CCB 8280
Pre and Post Change Summary
PCN #: CAAN-20JGKC128

Plastic Reel (Tape and Reel)

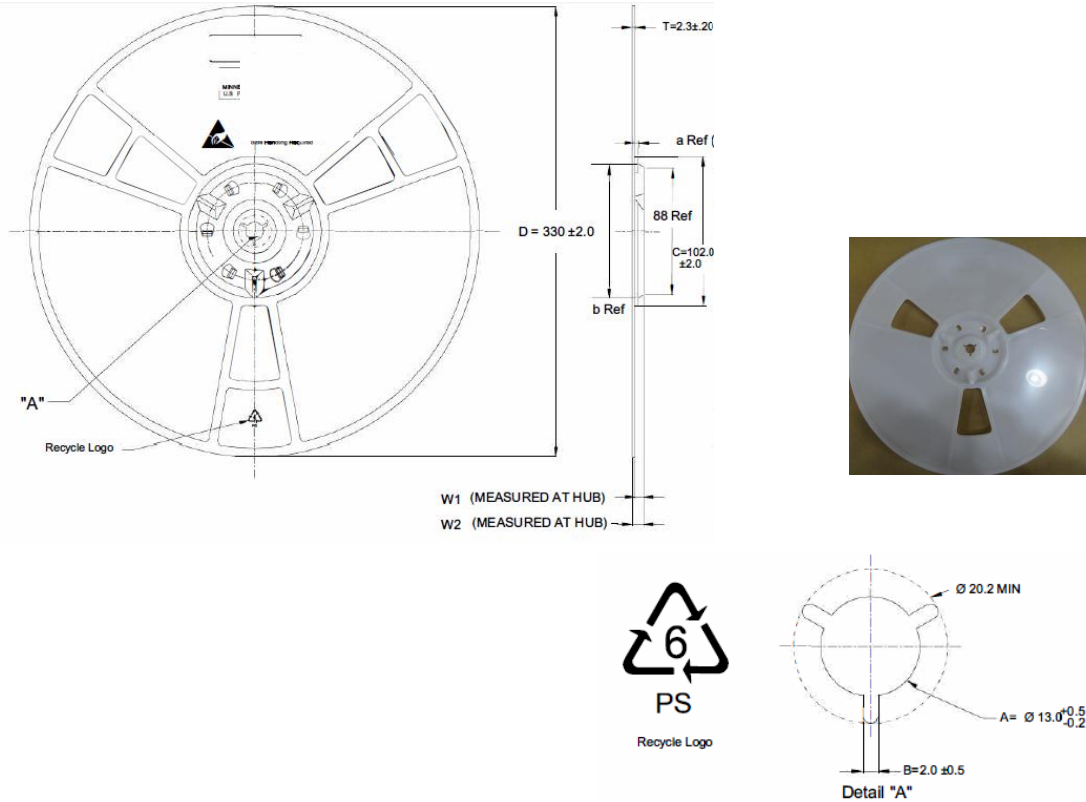
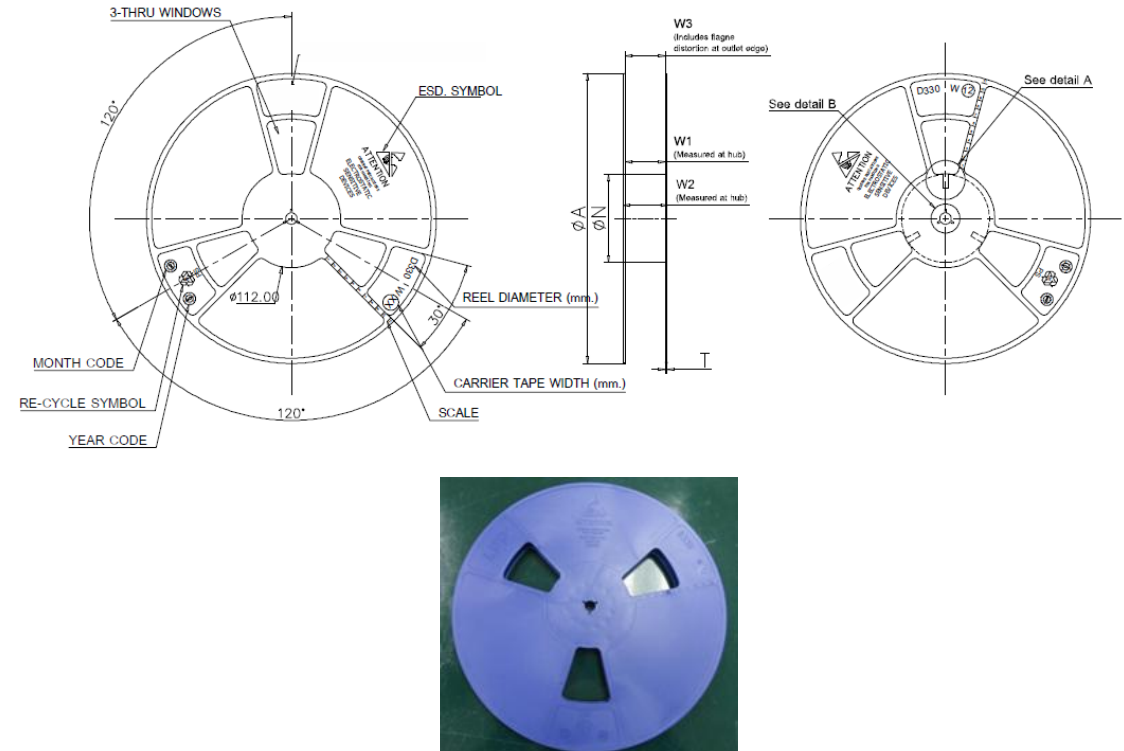
Plant	Reel Diameter (mm)	Reel Hub Size (mm)	Reel Width Max (mm)	Color
SIGT	330 ± 2.0	102 ± 2.0	18.20	White
MTAI	330 ± 2.0	100 ± 2.0	18.40	Dark Blue

Bag (Tape and Reel)

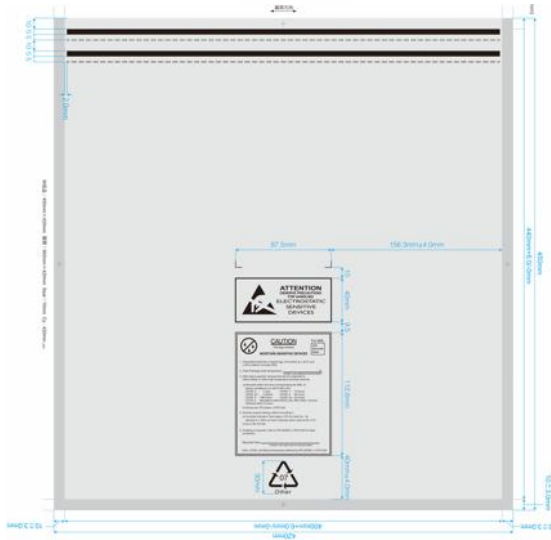
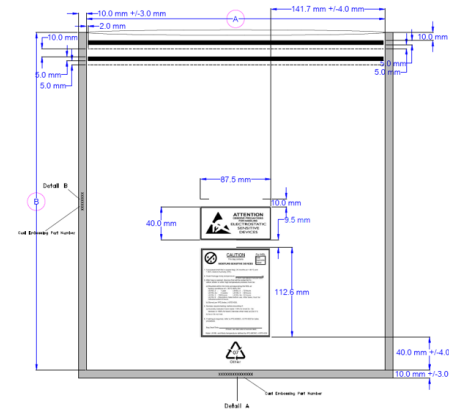
Plant	Bag type	Bag type	Length (mm)	Width (mm)	Thickness (mm)
SIGT	MSL-3	Moisture Barrier Bag	450 +3/-3	420 +3/-3	0.180 ±0.01
MTAI	MSL-3	Moisture Barrier Bag	420 +6/-0	370 +6/-0	0.1016

Desiccant (Tape and Reel and Tray)

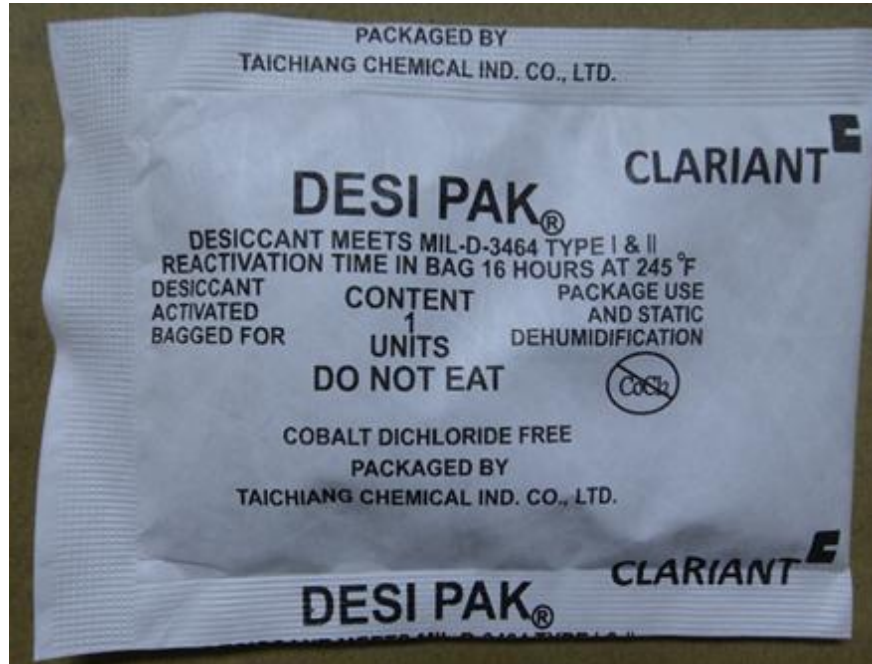
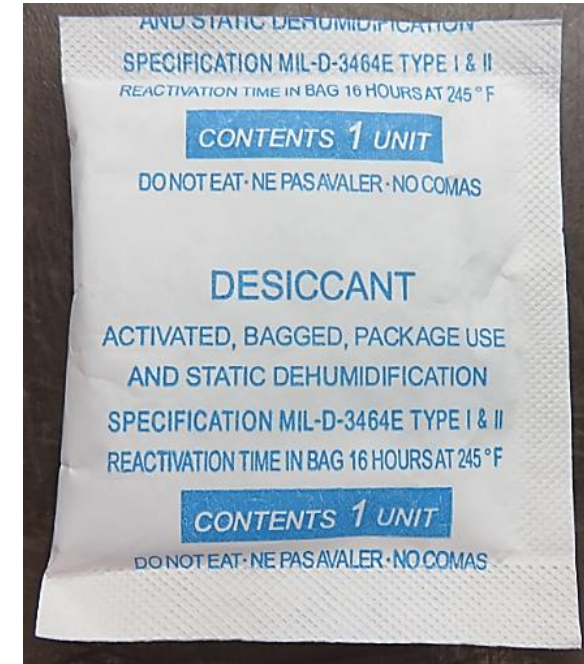
Desiccant each unit is 33 g

Desiccant each unit is 33g

Packing Method (Tape and Reel)

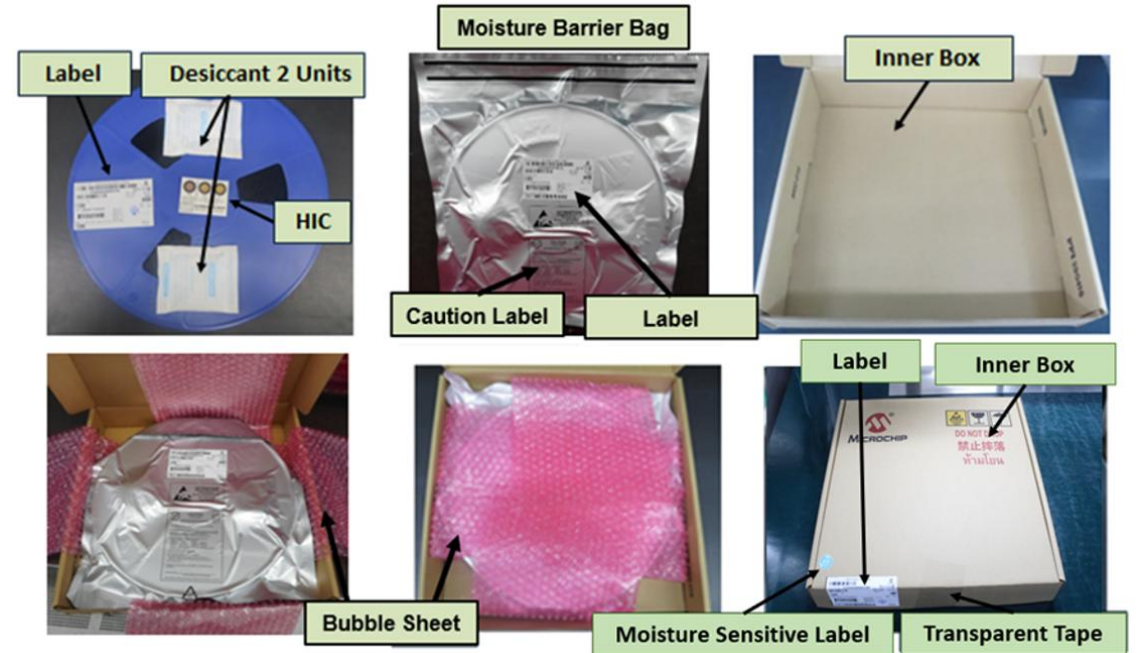
Inner box
Dimension
W x L x H (cm)
35.6x34x5mm

Inner box
Dimension
W x L x H (cm)
37x35.1x5.3
